**From:** [REDACTED]  
**Sent:** 16 April 2018 10:36  
**To:** Litherland, Jenna  
**Subject:** RE: 2017/6325/P & 2018/0701/P- Centric Close Conditions 16 (PVs), 17 (CHP), 18 (Mechanical Ventilation)  
**Attachments:** Renewable Site Summary 3.1 Windows 1.3 G 0.45 - 13.9KWP to residential u....pdf; Centric Close Design and Schematic Issued for Approval (28-09-17).pdf

**From:** Litherland, Jenna [mailto:Jenna.Litherland@camden.gov.uk]  
**Sent:** 12 April 2018 13:52  
**To:** David Chalmers  
**Subject:** 2017/6325/P & 2018/0701/P- Centric Close Conditions 16 (PVs), 17 (CHP), 18 (Mechanical Ventilation)

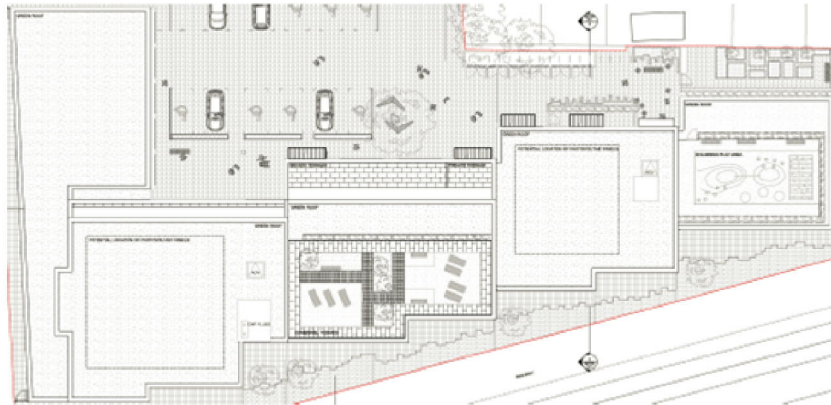
**Officer comments:** The submission 'PV electrical schematic' and 'Roof Plan' show 56no. 250Wp solar PV panels, arranged in two electrical strings of equal capacity (5.75 kWp) giving a total capacity of 11.5 kWp. The strings feed into a 15kW inverter with twin 'maximum power point tracking' capability.

Concern 1 This capacity is not sufficient to implement the approved scheme. The document 'Centric Close Energy and Sustainability Addendum' dated 9 March 2017, prepared by Low Energy Consultancy Ltd states that:

If energy yield were uniform across the array, the proposed downsizing would lead to a theoretical 17% shortfall in CO2 reduction against the approved scheme. This change risks causing it to miss its approved overall CO2 target of 35% (and is likely to affect compliance with the separate Be Green renewables 20% target). However no calculations or updates were submitted to update the Energy Statement accordingly. Likewise to no variation has been approved to permit this material change.

Concern 2 The cross-section drawings 'Roof details' show the makeup of the flat roof but do not show any sample PV equipment in cross-section eg to demonstrate the frame height, tilt and separation distances. This would demonstrate the design thought given to avoiding self-shading effects.

The PV schematic shows 4 strings of 14 modules to give 56 modules in total with a peak capacity of 14kWp (56 x 0.25kW). This is sufficient to satisfy the planning requirements as indicated from the design SAP calculations (see summary sheet attached for reference).

PV layout – draft design shows 56 panels (modules) arranged on the roof of block A. If required - we can provide sections showing modules fixed using the mounting system, the angle of tilt, separation distances, inverter and generation meter locations.

#### System details

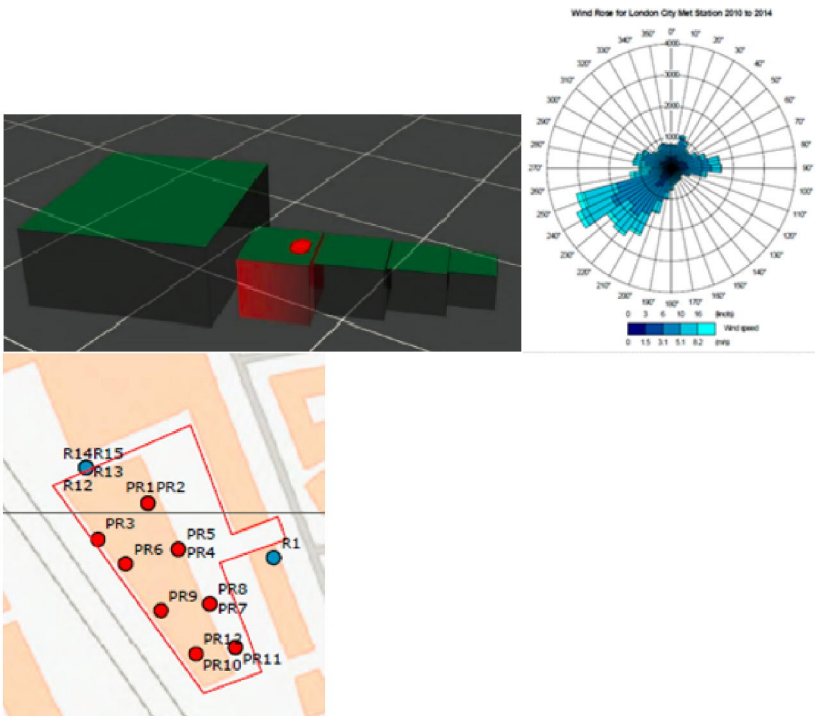
The information provided is sparse. The principle of using high-efficiency MVHR with intakes fitted with G3 filters is acknowledged. However

1. no further product details or site-specific maintenance plans are supplied. These would be expected within the submission to help demonstrate the effectiveness and durability of the proposed systems.
2. a key pollutant of concern is assumed to be NO<sub>x</sub>, therefore NO<sub>x</sub> (activated carbon etc.) filters would have been expected (instead of or) in addition to the proposed particulate (G3) filters.
3. no information is provided about whether windows are non-openable in the flats supplied by MVHR (this should be the case for system efficiency and air quality reasons).
4. finally, little mitigation is gained by installing mechanical ventilation systems which have air intakes on the elevation adjacent to the main pollution sources – see discussion below on location of intake vents.

Units facing the railway will all be specified with MVHR systems with G3 filtration. Additional G4 (NO<sub>x</sub>) filters can be specified if this is considered necessary, albeit there are no NO<sub>x</sub> mitigation requirements. NB G4 and G3 filters are fitted inside the dwellings on the supply side of the ducting system. It is not necessary to move the supply inlets or extract outlets from the railway façade (as confirmed by the air quality report).

Although all windows on the railway façade will be openable, MVHR systems are used to ensure fresh air can be supplied to meet all acoustic, ventilation and overheating requirements without opening windows. Occupants will be made aware of this in their Home User Information, along with details of any maintenance requirements (filter changes etc.).
